Access Compliance Report Public Rights-of-Way (Curb Ramps)

Main Street: **OSO_PKWY** Cross Street: **ANTONIO_PKWY** Location: **NW**

ADA ID: **RPRK211019122813** Ramp Type: **Type 1 - Perpendicular** Initial Pass/Fail: **Fail** Overall Compliance: **No** Severity Score: **16**

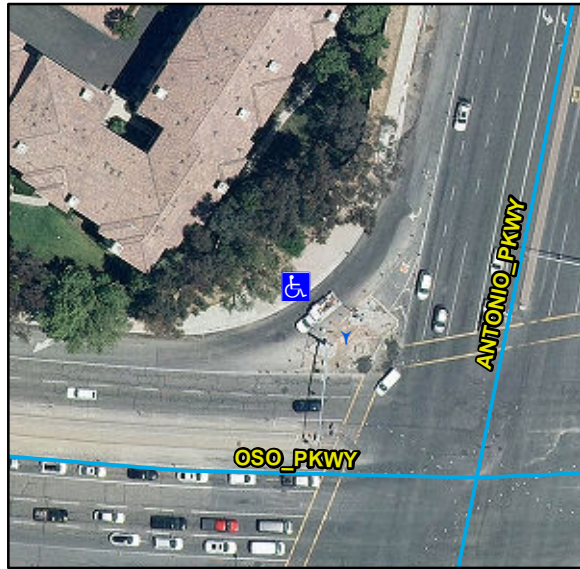
Compliance	Description	Data	Compliance	Description	Data
N/A	Ramp Length (in)	97	N/A	Flare Type LT	
Yes	Ramp Width (in)	48			N/A
No	Ramp Run Slope (%)	8.8	N/A	Flare Slope LT (%)	N/A
Yes	Ramp Cross Slope (%)	1.9	N/A	Flare Traversable LT	N/A
N/A	Landing Present	N/A	N/A	Flare Type RT	
N/A	Landing Length (in)	N/A			N/A
N/A	Landing Width (in)	N/A	N/A	Flare Slope RT (%)	N/A
N/A	Landing Run Slope (%)	N/A	N/A	Flare Traversable RT	N/A
N/A	Landing Cross Slope (%)	N/A	N/A	DWS Provided	N/A
N/A	Landing Movement Obstructed?	N/A	N/A	DWS Contrast	N/A
	Landing Movement Type	N/A	N/A	DWS Length (in)	N/A
N/A	Landing Shared	N/A	N/A	DWS Full Width	N/A
N/A	Clear Space	N/A	N/A	DWS Offset Left (in)	N/A
N/A	Clear Space To Crosswalk (in)	N/A	N/A	DWS Offset Right (in)	N/A
N/A	Marked Crosswalk 1	Yes	N/A	Marked Crosswalk 2	N/A
	Crossing 1 Direction	SE		Crossing 2 Direction	N/A
	Marked Crosswalk 1 Width (in)	144		Marked Crosswalk 2 Width (in)	N/A

Remove & Replace Entire Ramp.

R304.2.2, STD 1115
